Exception Request: No. 7
Section: WBR3
Station: 2531+00 to 2575+20
Drawing No.: WBR3 C223 to C229
Survey Report Cross Reference No.: WBR3 C220 to C225
Exception Type: Alignment in Pavement
Splice Enclosure in Pavement
Crossing Over Existing Utility/Drainage

NORTHERN PASS TRANSMISSION (NPT) PROJECT

THE STATE OF NEW HAMPSHIRE
DEPARTMENT OF TRANSPORTATION

The Department has reviewed the Sample Submission and Request for Exception to the NHDOT Utility Accommodation Manual (UAM). The following comments are to be incorporated into future submissions:

EXCEPTION 7-ALIGNMENT IN PAVEMENT & CROSSING OVER EXISTING UTILITY/DRAINAGE. NPT WBR3-UNDERGROUND ALIGNMENT WBR3 SECTION-STA. 2532+00 TO STA. 2575+20
SCALE: 1"=60'

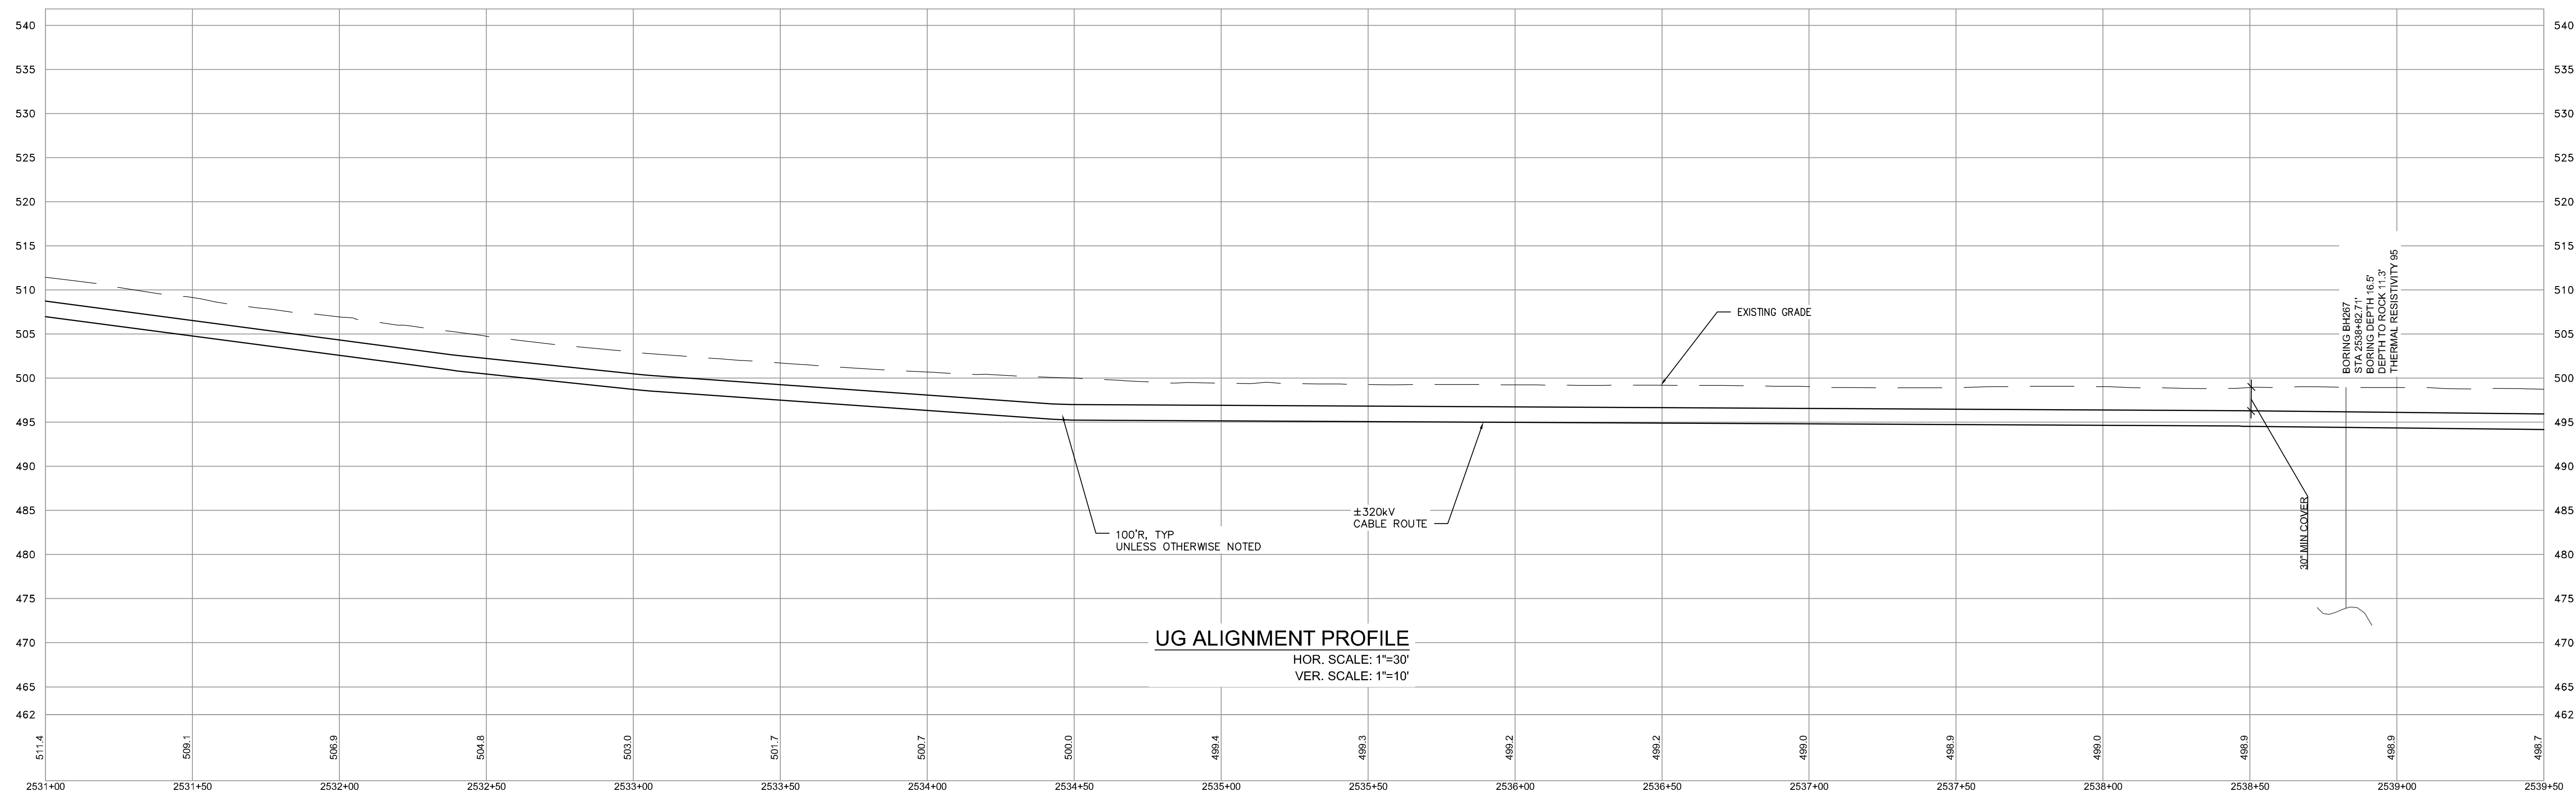
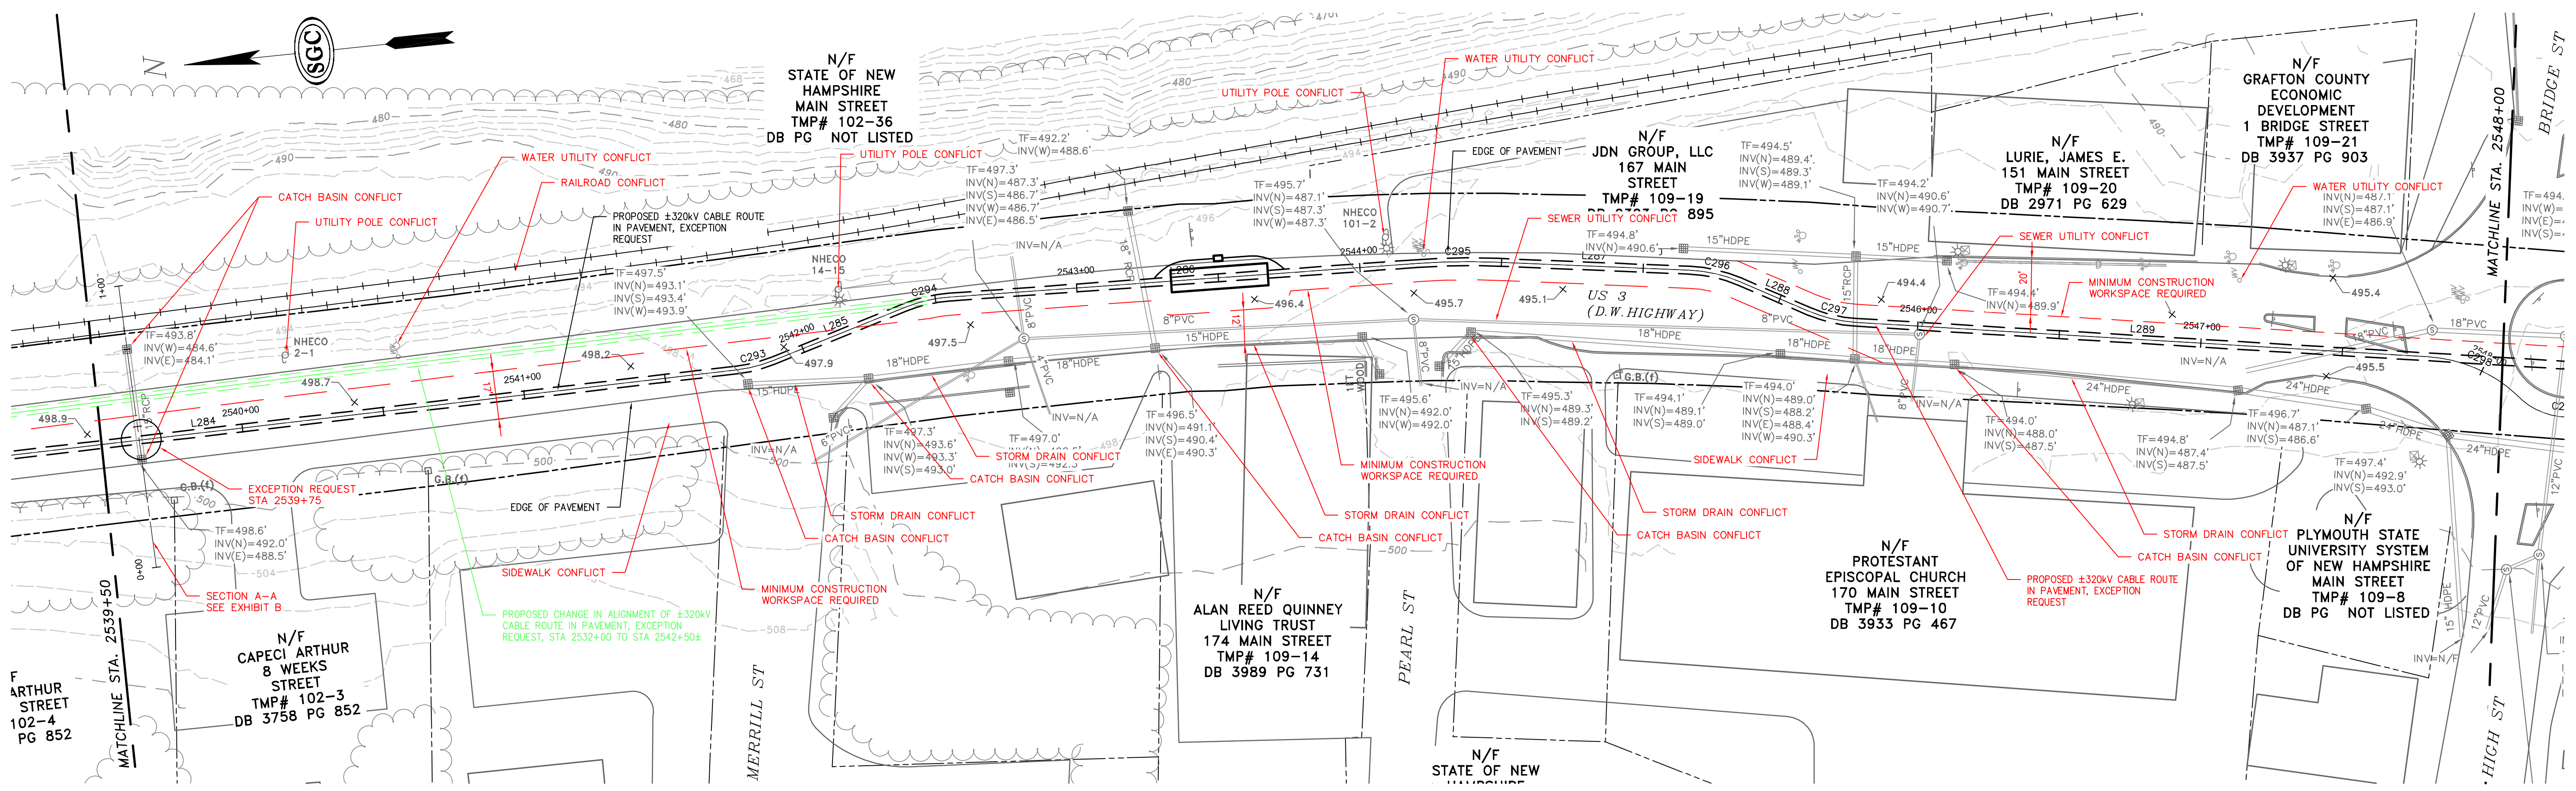
NPT is requesting an exception from the UAM guidelines for the location of the cable trench in the pavement on US 3, Daniel Webster Highway from station 2531+00 to 2575+20 of the NPT WBR3 underground alignment section, sheets WBR3 C223 to C229 and the splice enclosure at STA 2561+80. Due to limited ROW space and conflicts with terrain, slope and existing utilities/drainage structures, construction outside the pavement is not possible. NPT does not have the necessary property rights to construct outside the NHDOT ROW. The proposed alignment is located beneath the pavement at a 5-foot offset from existing utilities to avoid future conflicts with repairs or replacement or disruption to the existing utilities.

In addition, the exception request in this area includes multiple crossings above existing utilities and drainage structures, specifically, a 15-inch reinforced concrete pipe (RCP) culvert and a 12-inch clay sewer. The proposed alignment is set within the pavement and over the existing utilities to avoid road closures and increased construction width that will extend the duration of construction and traffic impacts.

We have reviewed the alignment in this area and have proposed a change in the alignment to eliminate the road crossing at station 2523+48, as shown in Exhibit A. Due to the utility conflicts, the alignment would still be in the pavement but would be able to be constructed much closer to the edge of pavement than on the west side as currently proposed. This change would also eliminate a road crossing.

Route changes undocumented in Exception Requests.

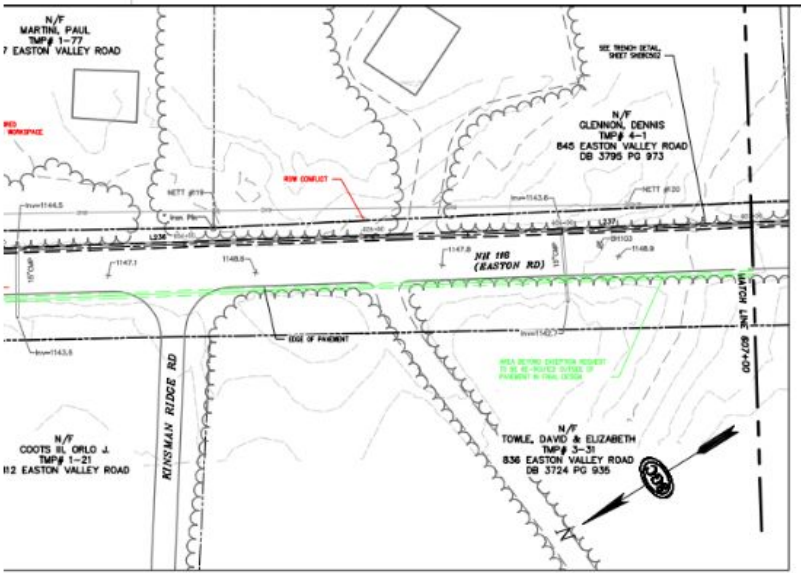
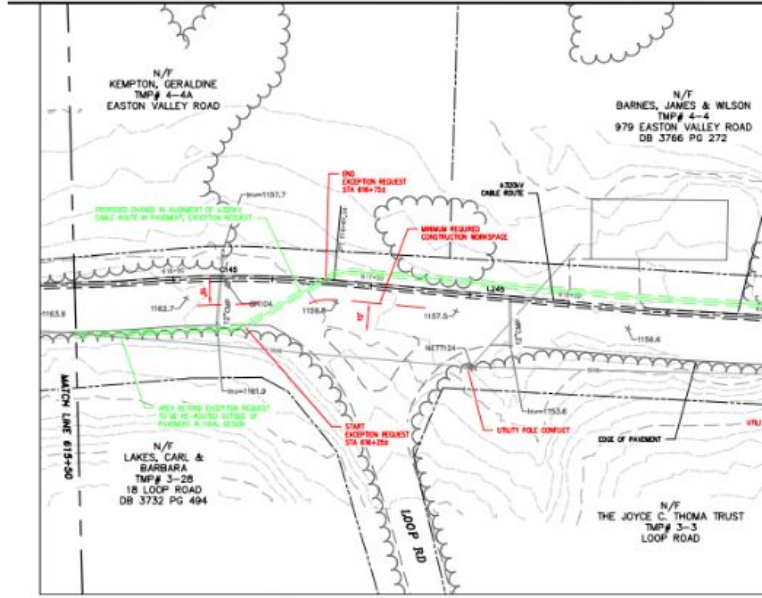
Trench on other side of road

Exception Request #101, Bethlehem. ROW shown as 4 rods = 66'

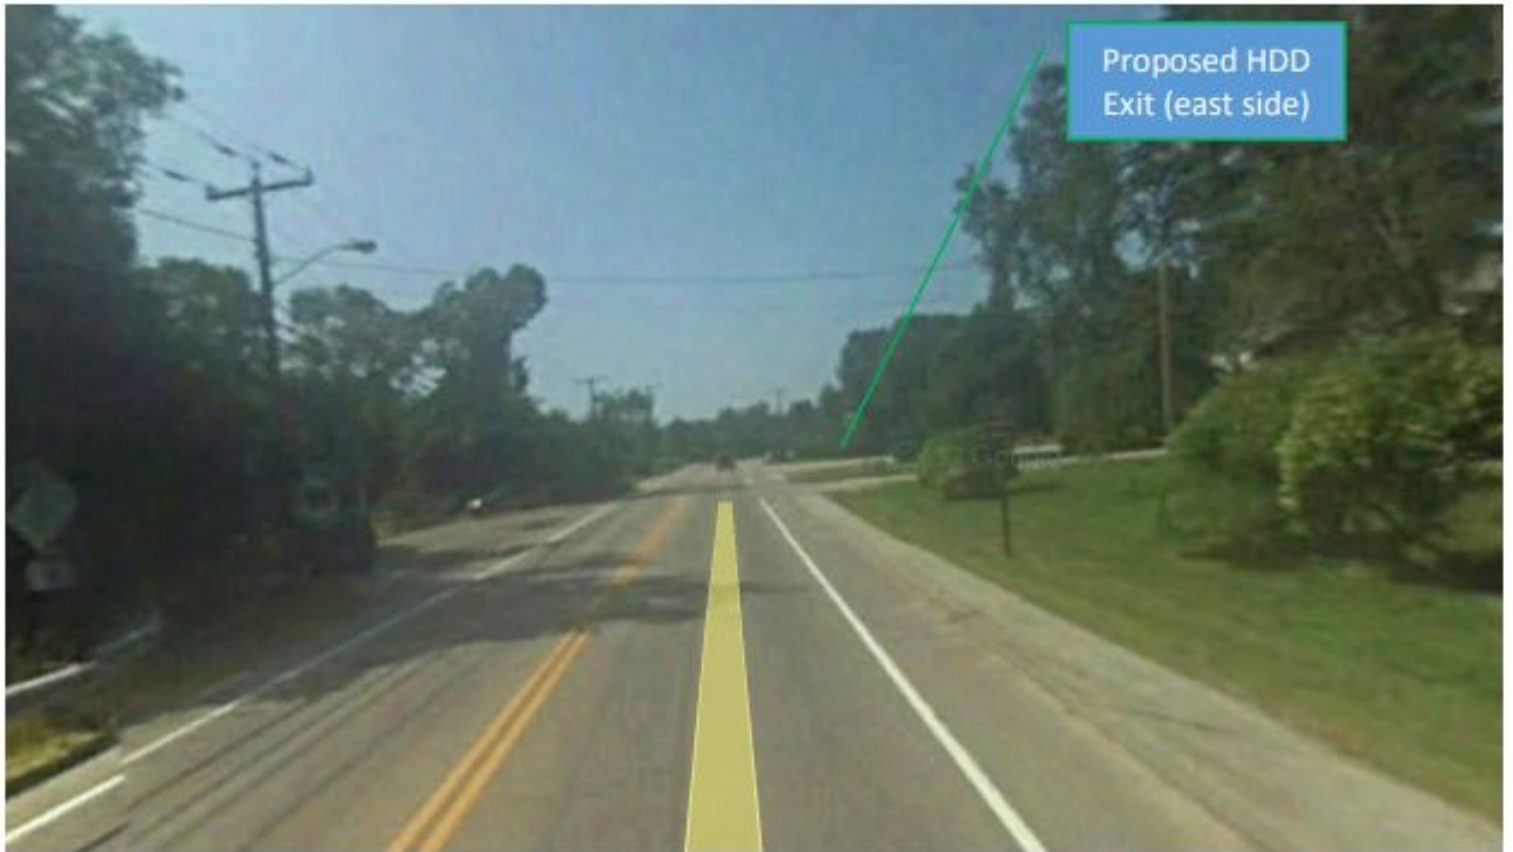
How would this work be done in a 2 rod ROW, per 1871 layout?

HDD workzone, Exception Request #104, Main St. Franconia.

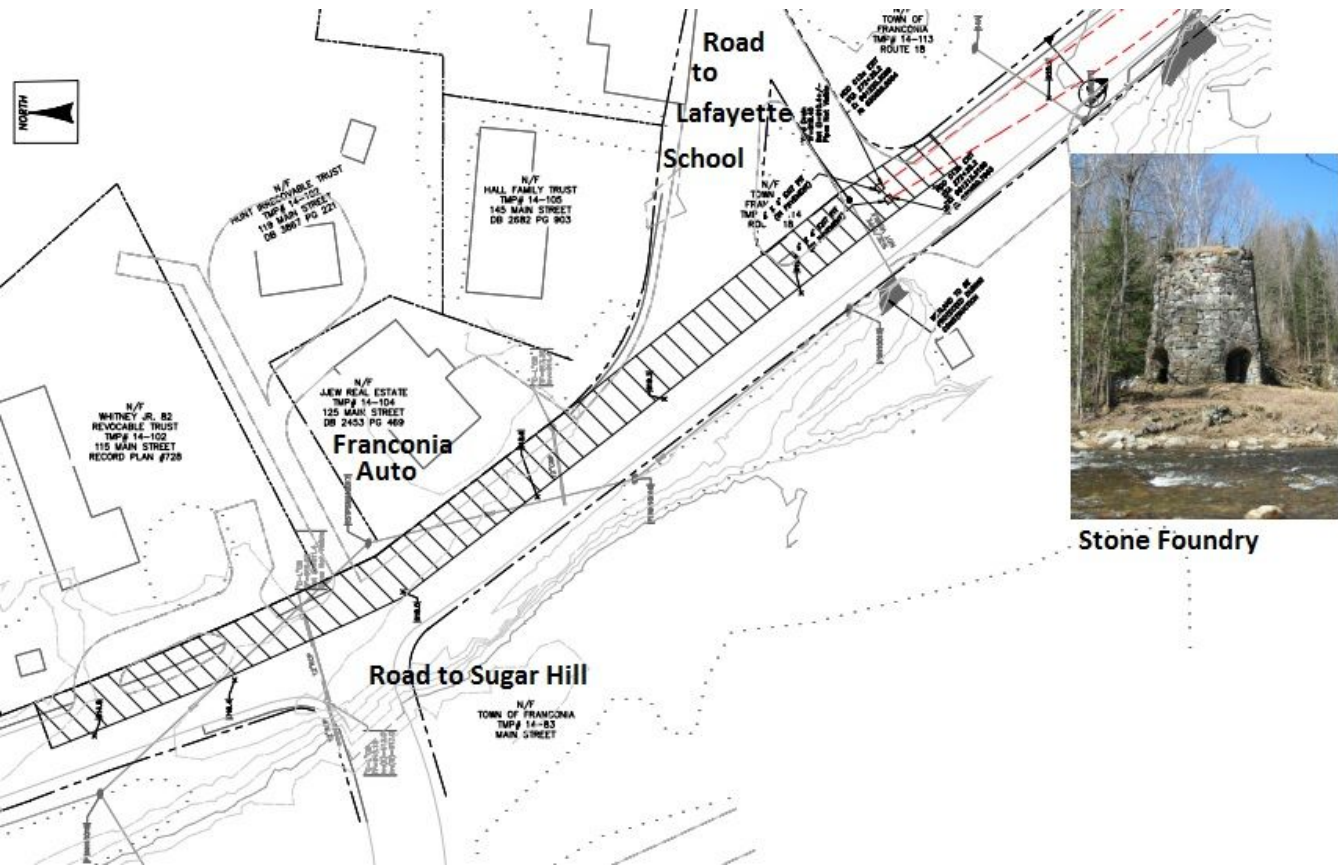
Blocking access to Lafayette, School, road to Sugar Hill, Franconia Auto, Lucy Hall's house, local clinic and close to sensitive historic resource.
